**DEPARTMENT OF COMMUNITY DEVELOPMENT SERVICES**

**m e m o r a n d u m**

**SUBJECT:** Plan Case 2276-PUD-16 & Plan Case 2277-PUD-1: A request on behalf of Vision Housing LLC for preliminary and final approval of a residential Planned Unit Development at 802, 804, and 806 South Lincoln Avenue and 809 West Nevada Street under Section XIII-3 of the Urbana Zoning Ordinance.

4 5TH FLOOR PLAN  
A6 SCALE: NOT TO SCALE

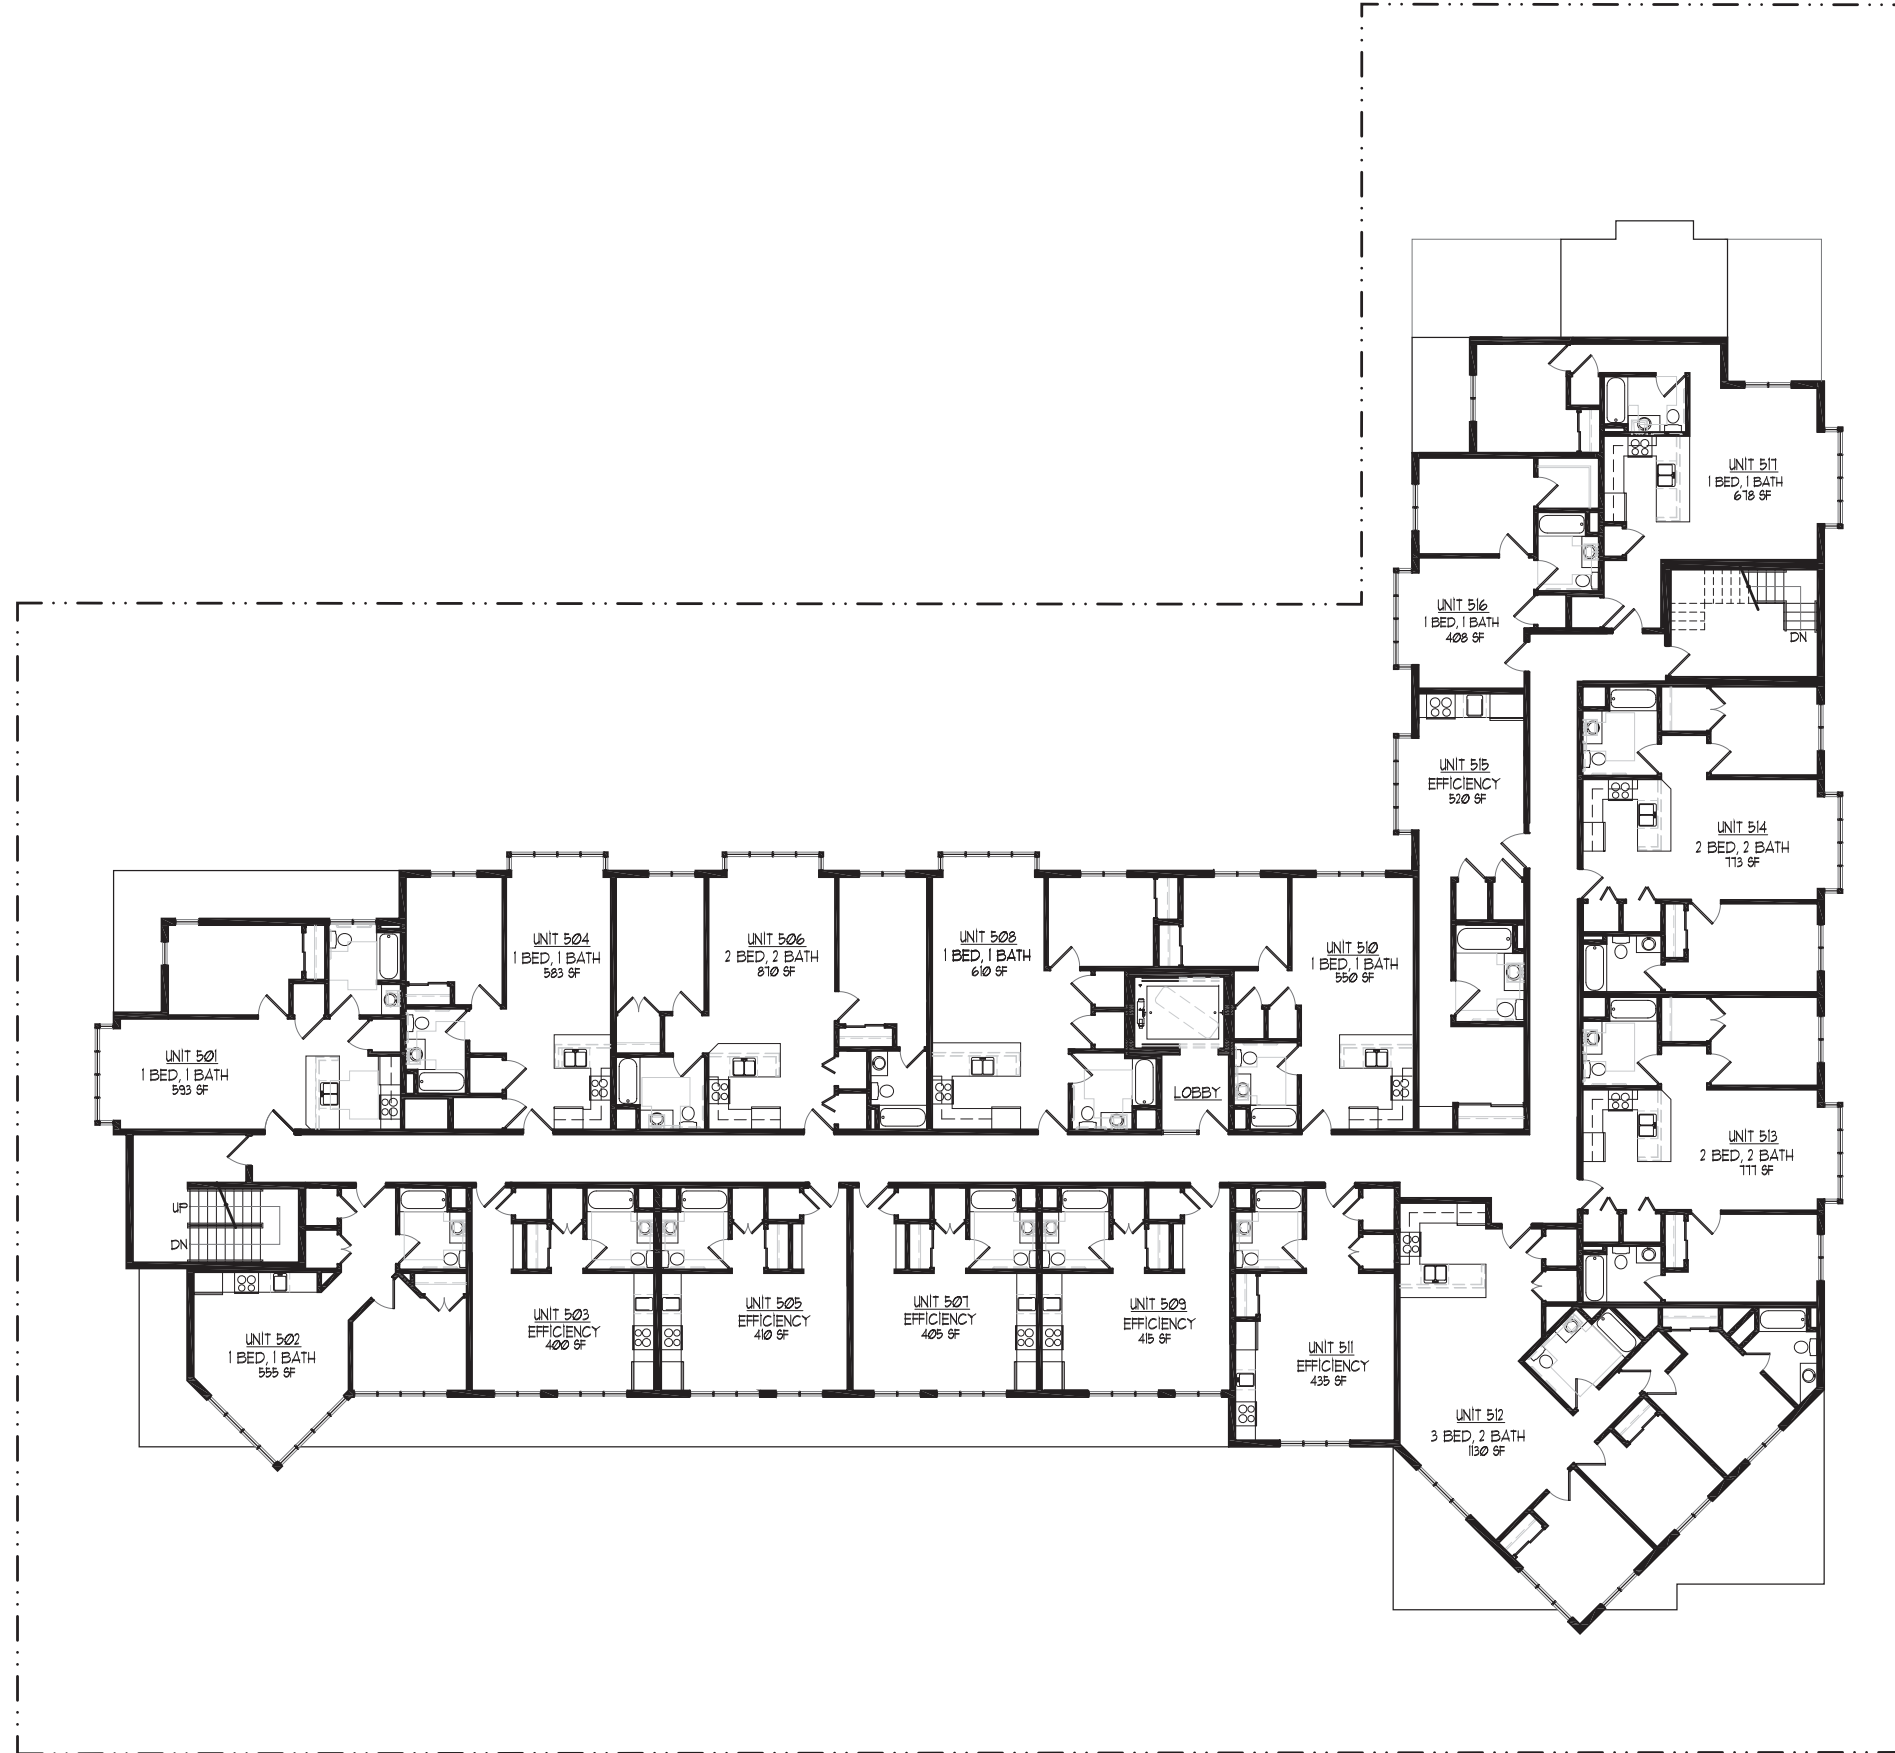
The applicant proposes a revision to reduce the number of units on the fifth floor along the east side of the building. The fifth floor is therefore is designed to be set back from the edge and finished with a lighter-color panel to reduce the perception of height. The building as a whole is proposed with large banks of windows to help interrupt the building's mass and provide visual interest. It is recommended that further revisions to the design be considered to reduce the building's apparent bulk and height and to further break up the building's mass.

2. That the design be reviewed and approved by the Design Review Board as specified by Section XI-15 of the Zoning Ordinance.
3. That the building design be revised to: a) consider eliminating the fifth floor and b) further break up the building's massing through articulation, use of a courtyard feature along Lincoln Avenue, or other means.
